**TO:** St. Francis City Council  
**FROM:** Beth Richmond, Planner  
**SUBJECT:** Rum River Preserve of St. Francis PUD  
**DATE:** 1101-2024 for 11-04-2024 meeting  
**APPLICANT:** Kinghorn Construction (Grady Kinghorn)  
**LOCATION:** 3503 Bridge St NW  
**COMP PLAN:** Commercial, HDR  
**ZONING:** B-1 Central Business District

## MEMORANDUM

**RE: Rum River Preserve**

**TO:** St. Francis Planning Commission  
**FROM:** Beth Richmond, Planner  
**SUBJECT:** Rum River Preserve PUD  
**DATE:** 10-8-2024 for 10-16-2024 meeting  
**APPLICANT:** Kinghorn Construction (Grady Kinghorn)  
**LOCATION:** 3503 Bridge St NW  
**COMP PLAN:** Commercial, HDR  
**ZONING:** B-1 Central Business District

DRAWING TITLE  
**CIRCULATION PLAN  
 (SEMI TRAFFIC)**

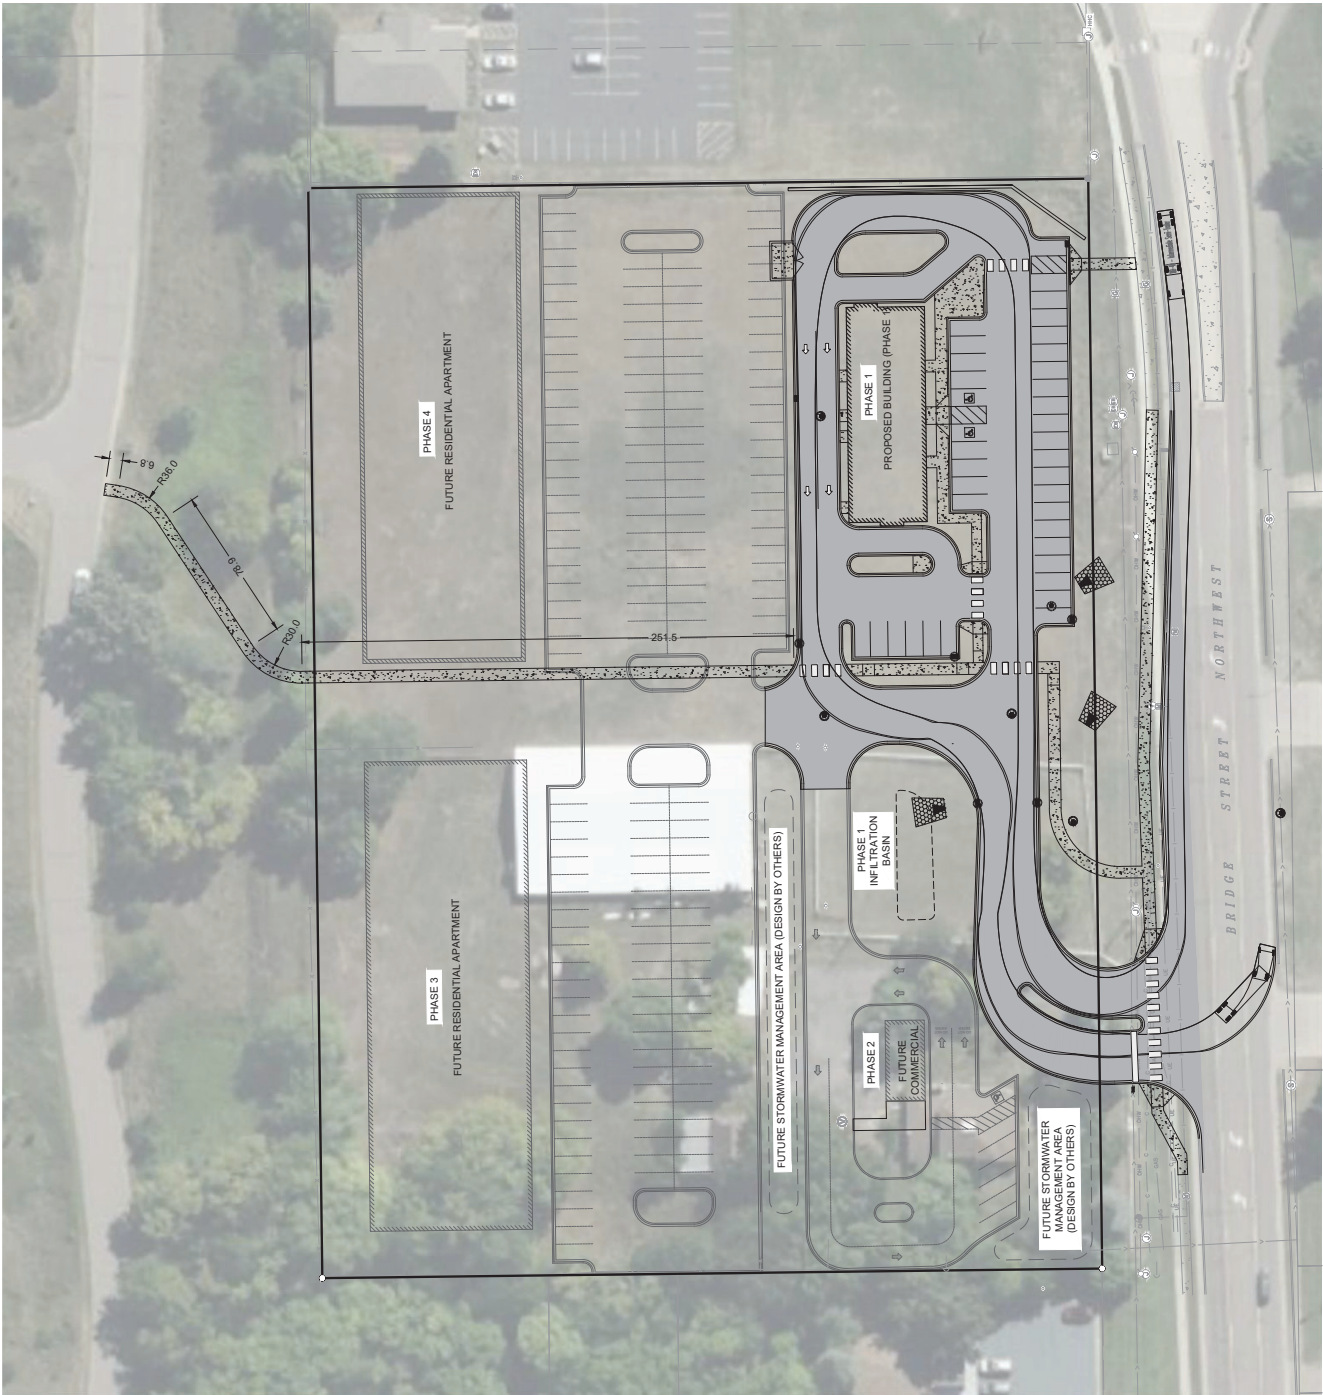
- PUD name has been changed to the “Rum River Preserve of St. Francis.”
- Circulation plans submitted for Phase 1 demonstrating how truck and passenger vehicle traffic will move through the site, including how circulation and queueing will be managed for both drive-thrus.
- Widened access road leading into the development and added a median to separate traffic.
- Updated landscaping plans for Phase 1 which include additional landscaping between Bridge Street and the parking lot including low-lying shrubs and deciduous trees to soften the impact of the parking lot and improve the pedestrian atmosphere of the corridor.
- Updated master site plan shows Phase 2 with the commercial building moved toward Bridge Street and the stormwater pond located behind the building. Staff is supportive of this layout change. More detailed plans for this area will be reviewed as part of Phase 2.
